TITEL: Ändring av fastsättning för säkerhetsbälte

GÄLLER: PZL-104 "Wilga 35" för flygplan som används för fallskärmshoppning

SERVICE BULLETIN NO. 1197173 MANDATORY

Concerns: Changes in the attachment of the forward starboard breast safety belt in PZL-104-Wilga 35 airplanes, accommodated for parachute jumping.

Fig. 1

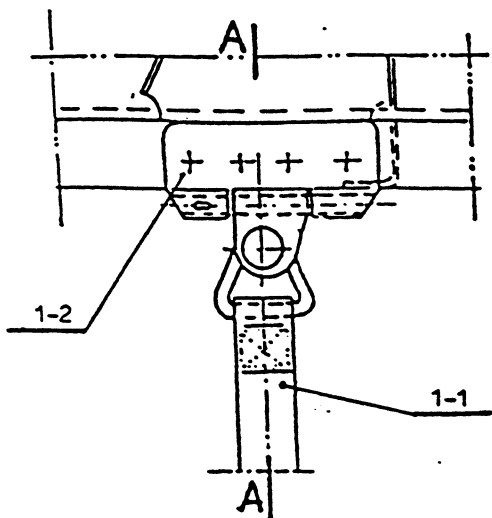
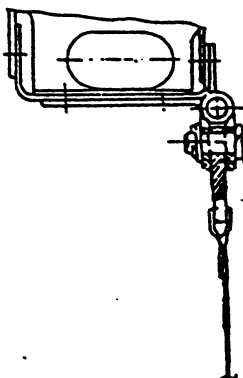
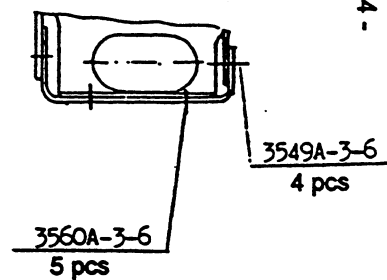
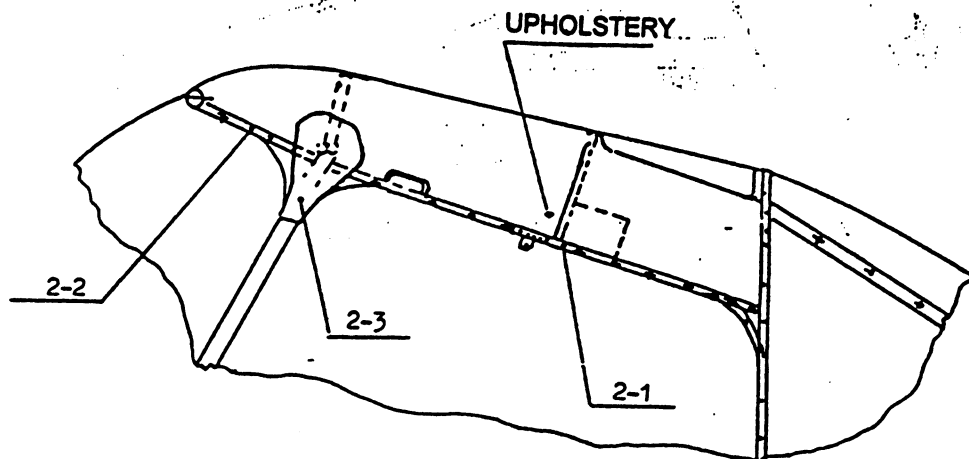
1. Disjoin the starboard breast safety belt No. 1-1 Fig. 1 [restore the bolt].
2. Unscrew at the R.H. side the shield No. 2-3 and the upholstery mouldings Nos. 2-1 and 2-2 of the door. Fig. 2 [the screws to be restored].
3. Deflect the upholstery.
4. Unrivet the ferrule No. 1-2 Fig. 1.
5. The holes remaining, to be plugged with rivets 3560A-3-6 – 6 each of, and 3549A – 4 each of, as in section A1 - A1 Fig. 1.
6. Drill holes according to measurements given in Fig. 3:
 - Ø 3,3 for rivets joining the upper flange of the bracket with the stringer
 - Ø 3,1 for rivets joining the lower flange of the bracket with the edge of the door.
 - Ø 2,7 for rivets joining the riveted nuts with the lower flange and the edge of the door.
7. Have riveted the bracket No. 3-1 according to Fig. 3, as per
8. Have bolted the ferrule No. 3-2 Fig. 3.
9. Have the upholstery cut as per Fig. 4.

Fig. 3

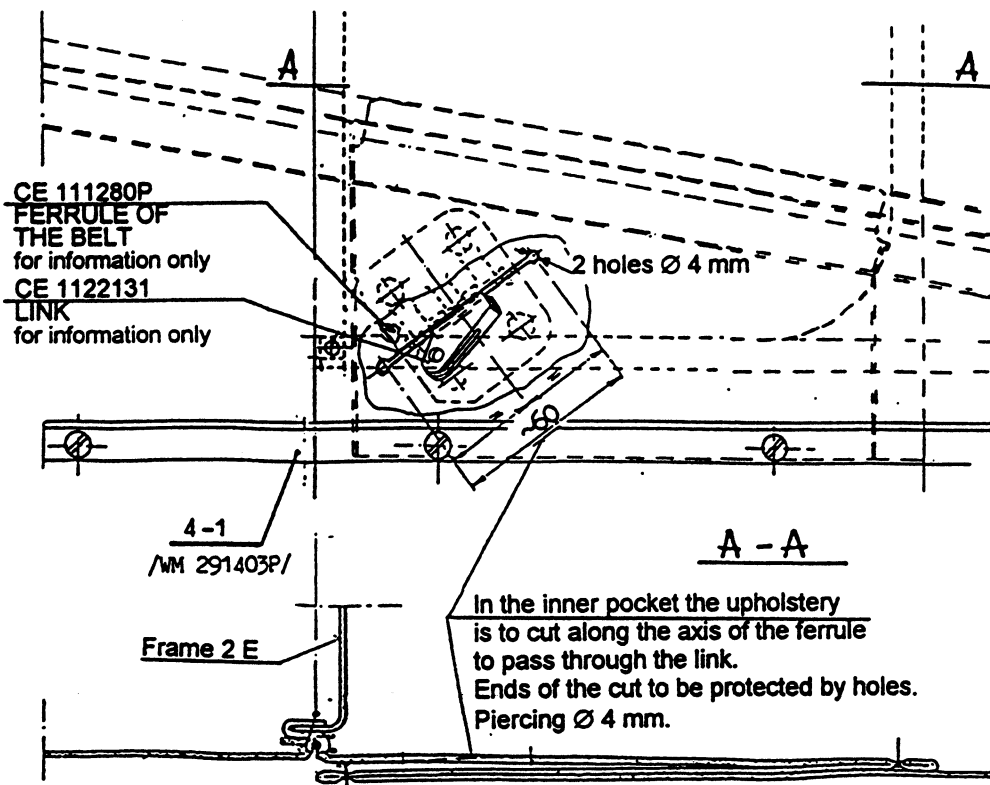
This bulletin is to inform, that in PZL-104 Wilga 35 airplanes utilized in parachute jumping operations, the upper ferrule of the starboard forward breast safety belt must be replaced by a new one and fixed and localized as shown in Fig. 3.

- 10. Relocate the upholstery, fix with screws the upholstery moulding No. 2-2 and a new moulding No. 4-1 instead of No. 2-1, and the shield No. 2-3.
- 11. Connect the breast safety belt No. 1-1 to ferrule No. 3-2.
